ALERT SERVICE BULLETIN

205B-17-67  
3 March 2017

**SUBJECT:** **MAGNETIC BRAKE ASSEMBLY 204-001-376-003, INSPECTION AND REPAIR OF.**

**HELICOPTERS AFFECTED:** Serial numbers 30188, 30166, 30066, and 30297.

**Figure 1. Magnetic brake assembly.**

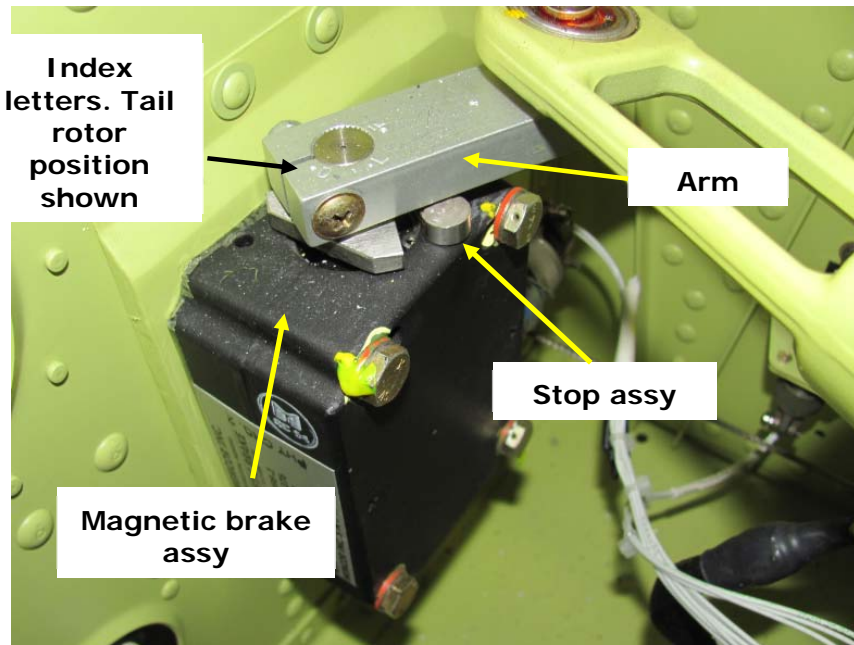
1. Prepare the helicopter for maintenance.
2. Gain access to the cyclic and tail rotor magnetic brake assembly (BHT-212-MM).
3. Perform a detailed visual inspection of the stop assemblies (Figures 1 and 2). Figures 3 and 4 show a stop assembly found disbonded.

Figure 3. Stop assembly with disbonded shaft.

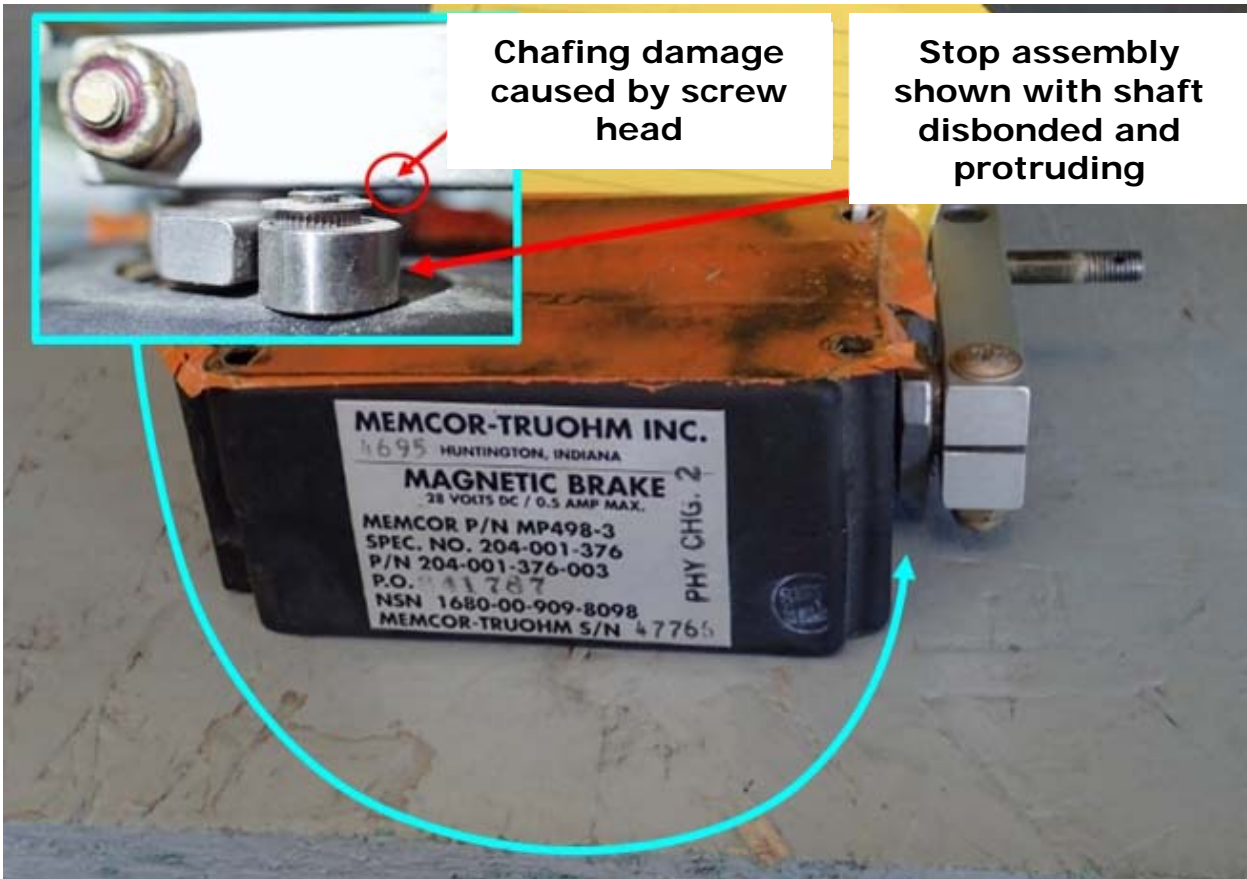
4. By hand, pull on the stop assembly to verify if the stop shaft is disbonded from the housing assembly.
5. If the shaft shows evidence of disbonding, inspect the lower side of the arm for possible chafing damage and accomplish Part II. The maximum allowable mechanical damage is 0.030 inch. (0.762 mm).

**Figure 5. Arm total travel.**

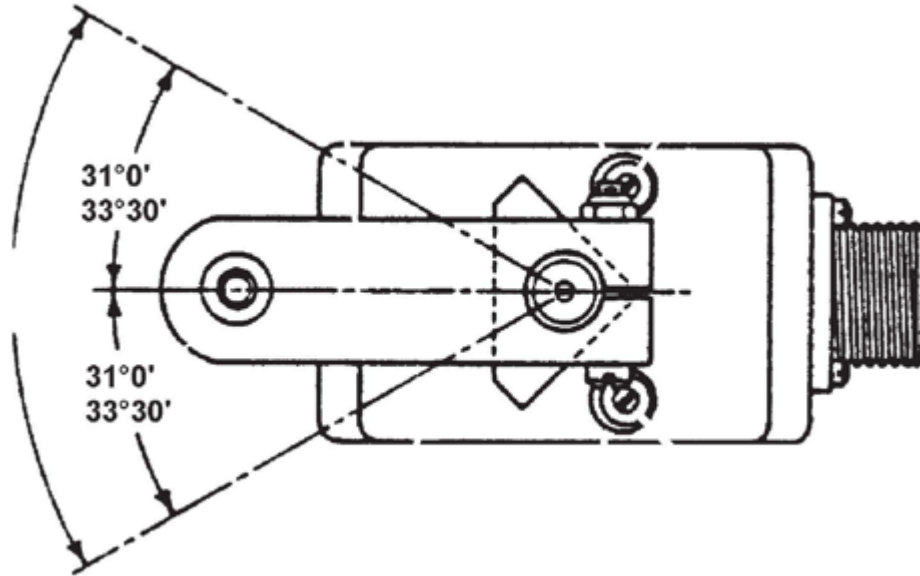
Regardless of arm letter indexing, in case the stop assemblies require adjustment for proper arm travel, refer to the Figure 5.

Regardless of arm letter indexing, total travel of the arm in relation to the stops is the same.
